Proposal to amend ECE/TRANS/WP.29/GRVA/2021/31

The text reproduced below reflects the discussion state of play of the Special Interest Group on Regulation No. 157 (Automated Lane Keeping System) up to its **eight** meeting, on raising the specified maximum speed of Automated Lane Keeping System (ALKS) up to 130 km/h. It is based on ECE/TRANS/WP.29/GRVA/2020/32 (submitted by Germany) and subsequent proposals for amendments received on this proposal.

GRVA-11-33: The entire text of ECE/TRANS/WP.29/GRVA/2021/31 is reproduced below. Modifications to this document are marked in **green bold** for new or **green strikethrough** for deleted characters.

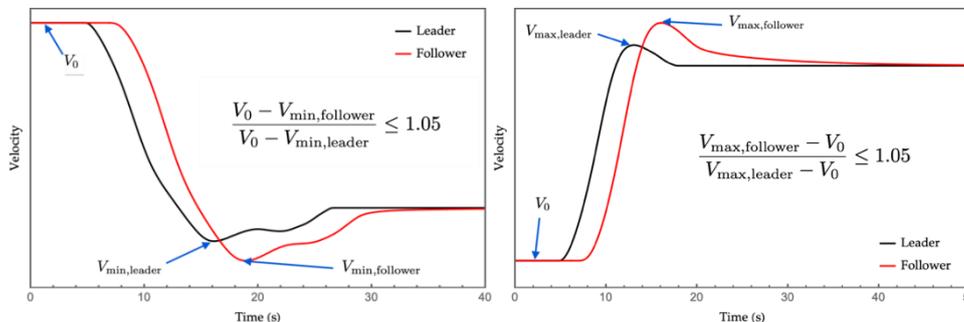
“5.2.10. While following another vehicle the ALKS vehicle shall aim to be string stable.”

~~In particular, when following another vehicle at constant speed and at a distance such that the speed profile of the ALKS vehicle is influenced by the speed profile of the vehicle in front, the ALKS vehicle shall aim to respond to a perturbation in the speed of the vehicle in front with a perturbation in its speed profile by at most a 5% increase in the maximum difference in speed compared to the vehicle in front before reaching a new equilibrium velocity following the visual examples reported in the following figures.~~

~~In addition, in the case when there is more than one ALKS vehicle in a chain following a vehicle under the conditions described in the previous paragraph, they shall aim to avoid further amplifying the perturbation caused by the lead vehicle from one vehicle to the next. The provisions included in this paragraph shall be demonstrated in accordance with Annex 4 of this Regulation.]”~~

- (j) ~~Group conclusion Point of discussion on 5.2.9. and 5.2.10: deleted without replacment (not needed due to other aforementioned amendments) Agreement to include some aspects of proposals from JRC/EC (working paper UNR157 03 06) on “string stability” as general requirements. Leadership to prepare proposal. → Group needs to review proposal by leadership.~~

Figure 1
Skilled Careful Competent and competent careful human performance model

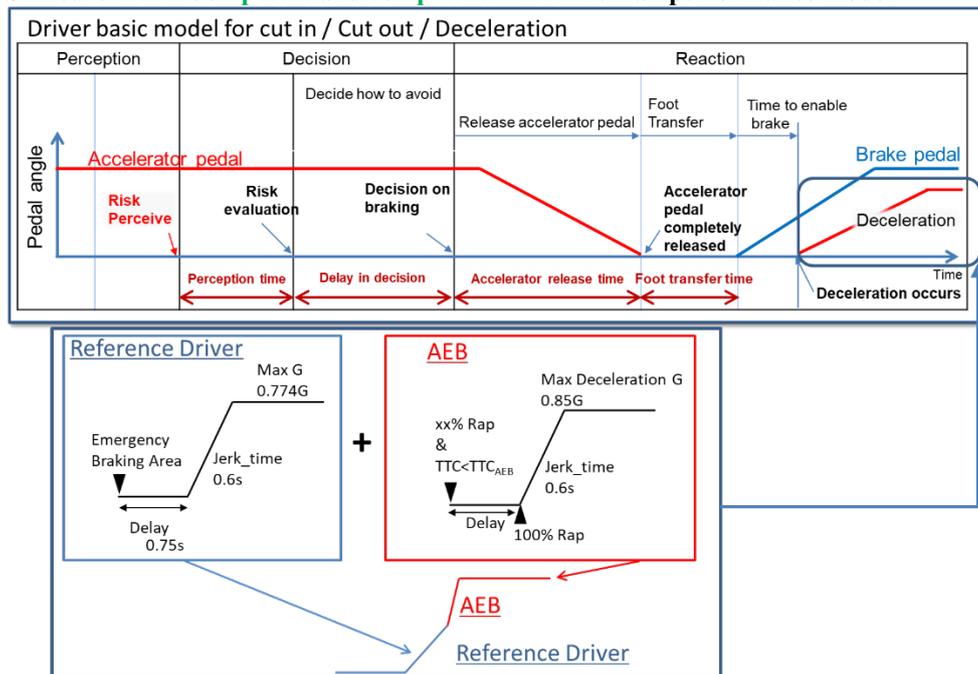
- 3.3. **“Performance model 1”**
 - 3.3.1. **In the first performance model**, the avoidance capability of the driver model is assumed to be only by braking. The driver model is separated into the following three segments: "Perception"; "Decision"; and, "Reaction". The ~~following~~ diagram **in Figure 1** is a visual representation of these segments.

- 3.3.1.1. To determine conditions under which Automated Lane Keeping Systems (ALKS) shall avoid a collision, performance model factors for these three segments in ~~the following~~ **Table 1** ~~table~~ should be used as the performance model of ALKS considering attentive human drivers’ behavior with ADAS.

Figure 6
Flow-chart of the second ALKS performance model for the case of the cut in traffic critical scenario

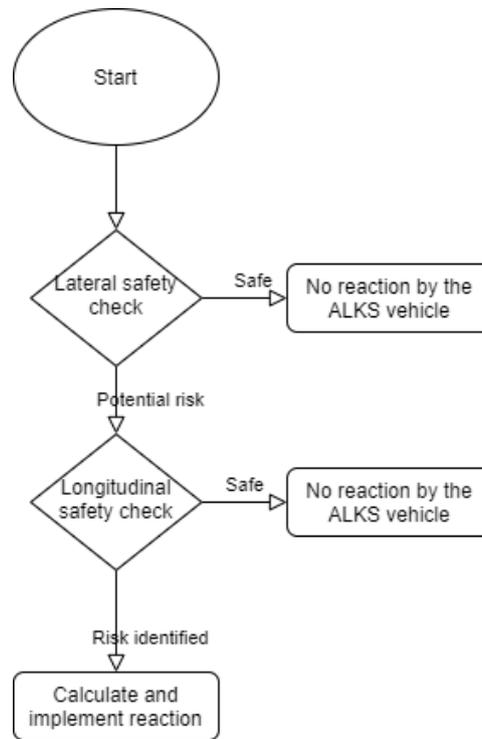
3.4.1. In the second performance model, it is assumed that the driver can anticipate the risk of a collision and apply proportionate braking. ~~apply proportionate braking actions in order to anticipate the risk of collision.~~ In this case, the performance model considers the following three actions performed by the competent and careful human driver: "Lateral Safety Check"; "Longitudinal Safety Check"; and, "Reaction". A Reaction is implemented only if the Lateral and Longitudinal Safety Checks identify a risk of imminent collision. The diagram reported in Figure 2 provides a visual representation of the decision flow followed by the driver in the second performance model for the case of the cut-in traffic critical scenario.
